ARLINGTON COUNTY, VIRGINIA

**County Board Agenda Item
Meeting of January 22, 2011**

SUBJECT: SP# 6 SITE PLAN AMENDMENT for a rooftop sign and a comprehensive sign plan; located at 4420 N. Fairfax Drive (RPC#: 14-051-019).

A NORTH ELEVATION: TOP TENANT SIGNAGE

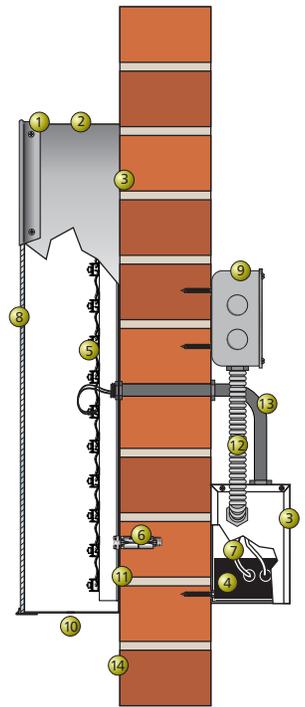
ROOFTOP SIGN				
Sign Type (Quantity)	Area (sq. ft.)	Text	Location	Materials
Westwood College Rooftop sign (1)	Approx. 125 sq. ft.	Westwood College	On the northern side of the building facing Fairfax Dr.	Aluminum lettering.
Sign area permitted per rooftop sign based on linear frontage	150 sq. ft.

The applicant is also proposing a rooftop sign above 35 ft. for Westwood College. The *Sign Guidelines for Site Plan Buildings* (Sign Guidelines) state that square footage for rooftop signs is based on one (1) square foot per one (1) linear foot of building wall width along the street frontage, and that the permitted area for the rooftop signs shall not count against the total sign area permitted for other types of signs. In addition, the proposed letter height is under the six (6) foot maximum permitted by the Sign Guidelines. Therefore, the proposal is consistent with the Sign Guidelines. The proposed sign faces office uses across the street and thus does not directly face residential or other areas identified as prohibited in the Sign Guidelines. Standard conditions for rooftop signs are proposed and agreed to by the developer. They require the applicant to turn off illumination of the signs at midnight and incorporate a rheostat.

- b. The developer agrees that the total sign area for all signs below 35 feet shall not exceed 86 sq. ft.
- c. The developer agrees that the total sign area for the rooftop sign shall not exceed 125 square feet.

- i. The developer agrees that the rooftop sign shall not be illuminated between the hours of midnight and 6:00 a.m., seven (7) days a week.
 - ii. The developer agrees to install a rheostat or other appropriate variable resistor that will allow the applicant to adjust (decrease) the rooftop sign's lighting intensity. The applicant further agrees that if the County Manager finds that the intensity of the rooftop sign's lighting has an adverse effect on the surrounding area, the applicant will, within 24 hours notice from the County Manager, reduce the intensity of the lights to a level that, in the County Manager's reasonable judgment, will no longer have such a adverse effect.

A, B, C, D NORTH ELEVATION: TENANT SIGNAGE

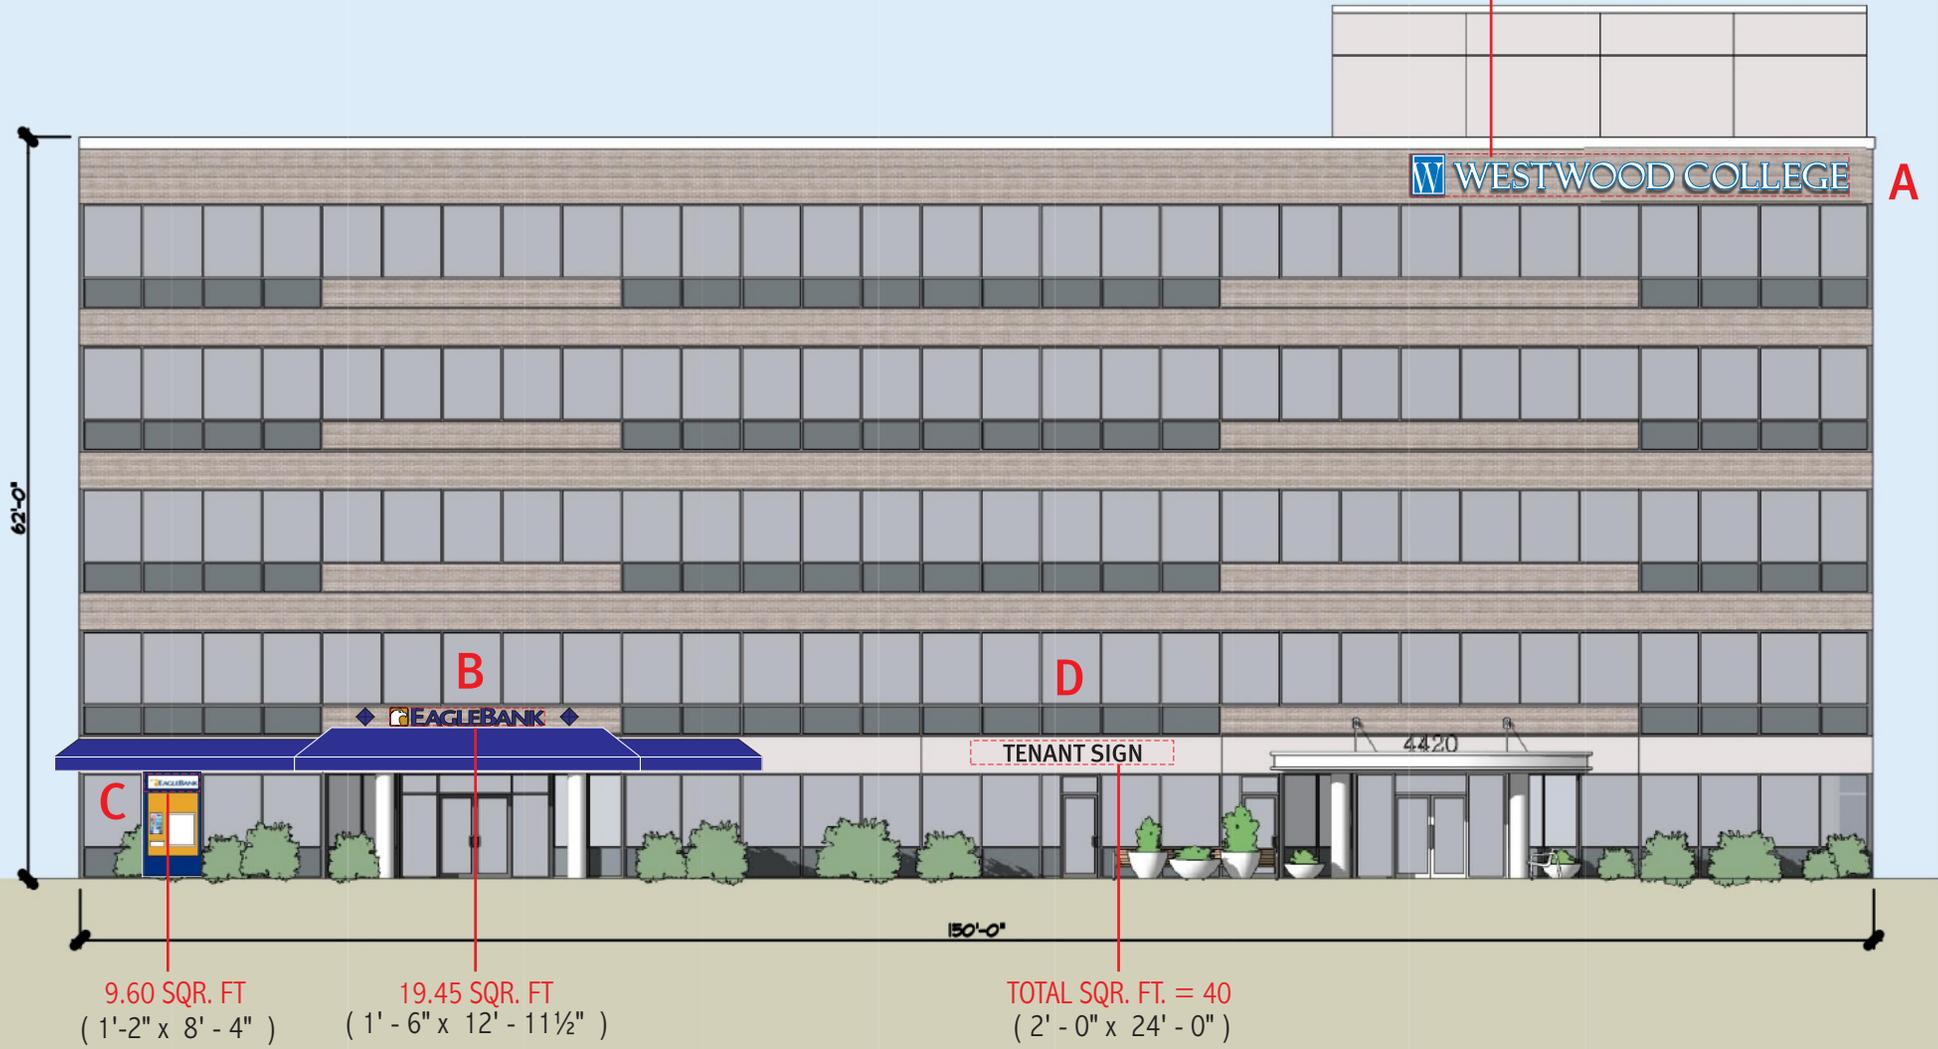
The proposed signs below 35 feet include three (3) retail signs for Eagle Bank (one wall sign and two ATM signs) and one (1) sign for a second retail tenant along Fairfax Drive. The Sign

Guidelines state that each retail tenant shall be permitted a maximum of two (2) identification signs, one (1) per tenant frontage. Eagle Bank is proposing three (3) signs total. There will be one (1) wall sign above the door facing Fairfax Drive, one (1) ATM sign facing Fairfax Drive, and one (1) ATM sign facing east. Three (3) signs are appropriate for this corner tenant. The proposed wall sign guides customers to the entrance to the bank. The proposed signs above each ATM let customers know what bank is associated with the ATM. This is especially important for the ATM on the east side of the building, as the bank signs facing Fairfax Drive may not be visible to pedestrians walking west approaching the building. In addition, the amount of sign area proposed for Eagle Bank is well within the sign area permitted. The Eagle Bank signs would total approximately 46 square feet, while 195 square feet of sign area is permitted based on the linear frontage of the building.
